**MEMORANDUM**

REVIEW TYPE: **Site Plan Review**
 CASE #: **82002036B**
 PROJECT NAME: Greenway Village at Clarksburg—Phases 1 and 2
 APPLYING FOR: Approval to add development standards for building heights and setbacks;
 revise conditions of approval for construction of the pool complex;
 relocate a mailbox; shift the placement of a bike path; modify grading for
 a stormwater management outfall; add a retaining wall to a single lot; and
 revise conditions of approval for the bike path along Skylark Road

AMENDED SITE DEVELOPMENT PLAN - PHASES 1 AND 2
GREENWAY VILLAGE AT CLARKSBURG
CLARKSBURG CMD ELECTRON DISTRICT
MONTGOMERY COUNTY, MARYLAND

Pool Complex

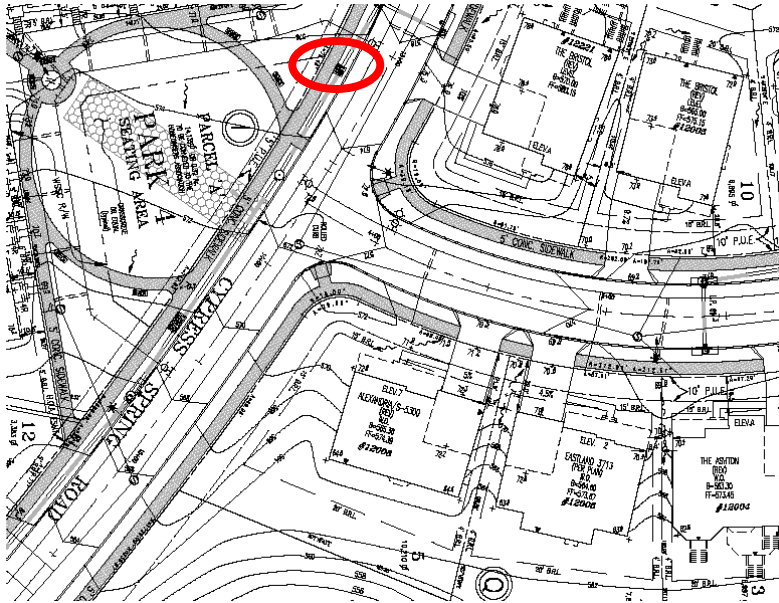
A previous amendment to this site plan (8-2002036A) revised the design of a planned pool house to include 2,000 square feet of community space. The approval conditions included a requirement that the pool house be completed before the earlier of two events: the achievement of 85 percent occupancy in phases 1 and 2, or June 1, 2006. Delays in approving the opinion for the site plan amendment and the subsequent signature set have made the June 1, 2006 deadline impossible to meet. This amendment therefore recommends that the applicant be required to complete the pool house by the time that 85 percent of all building permits are released by the Department of Permitting Services.

6. Recreation Facilities
 - a. The proposed pool house and community center complex in Park 3 is to be completed before 85 percent of all building permits are released by Montgomery County's Department of Permitting Services.

Bikepath Realignment

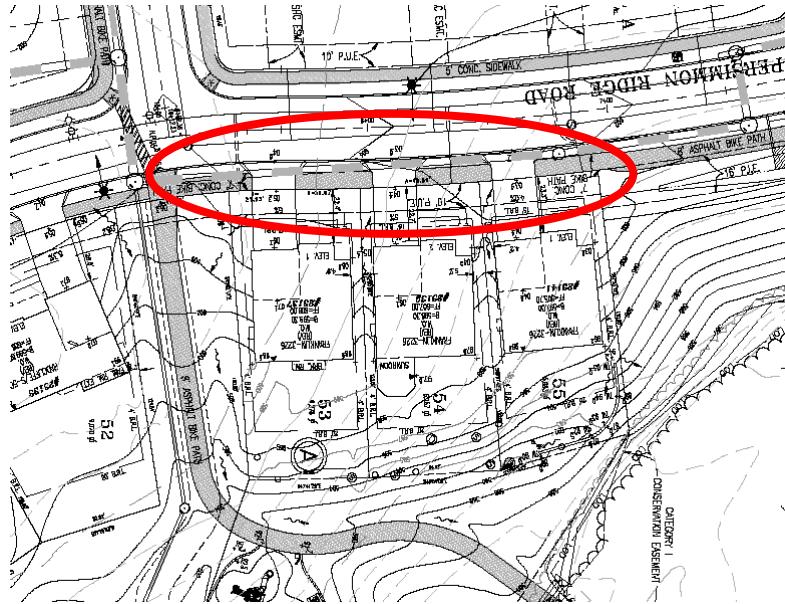
Greenway Village's circulation system includes bikepaths that will connect the neighborhood to the Clarksburg Greenway and to nearby Ovid Hazen Wells Recreational Park, as well as to other Clarksburg neighborhoods. One such trail connects Ovid Hazen Wells park to Clarksburg Village, using Cherry Branch Drive and Persimmon Ridge Road. The applicant is proposing to shift the alignment of a portion of the bikepath in front of three houses along Persimmon Ridge Road, so that it is located completely within the public right-of-way.

- b. The bike path required along the south side of Skylark Road must be completed concurrently with improvements to Skylark Road undertaken by the Department of Public Works and Transportation.

Modified Stormwater Management Outfalls

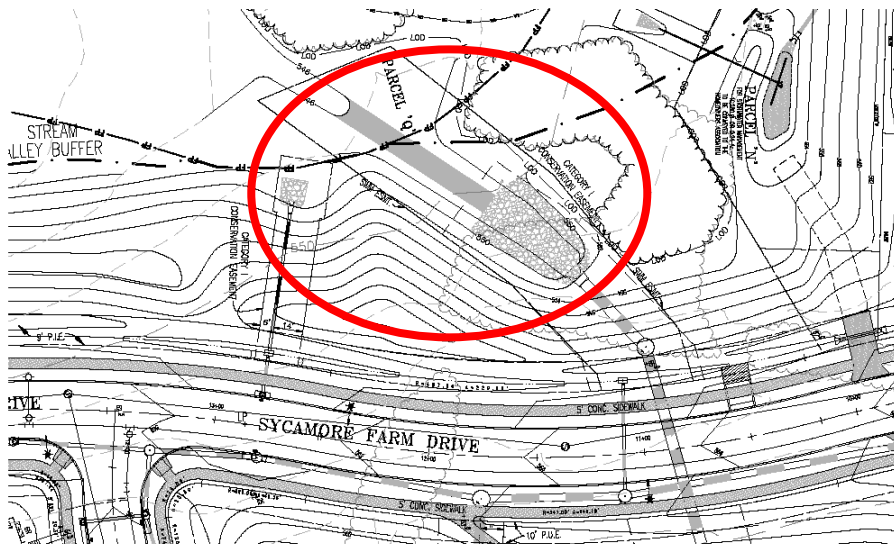
Detailed design of the stormwater management system adjacent to the pool complex requires extending the length of the outfall that will convey water to the stream that will accept the filtered stormwater. Extending the length of the outfall requires revised land grading in the area of the outfall. The applicant proposes to alter the grading as part of this amendment.

Environmental Planning Unit staff has reviewed this proposal and recommends its approval.

Addition of Retaining Wall

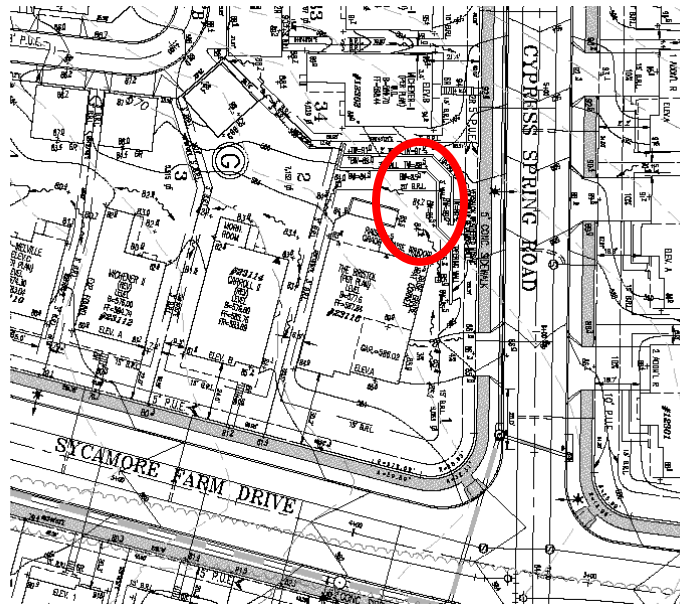
During field grading of Lot 1, Block G at the corner of Cypress Spring Road and Sycamore Farm Drive, the house's basement was located at a lower elevation than originally planned. The applicant proposes to correct the difference in elevation by constructing a retaining wall in the portion of the lot nearest Lot 34, Block G, which is immediately adjacent on Cypress Spring Road.
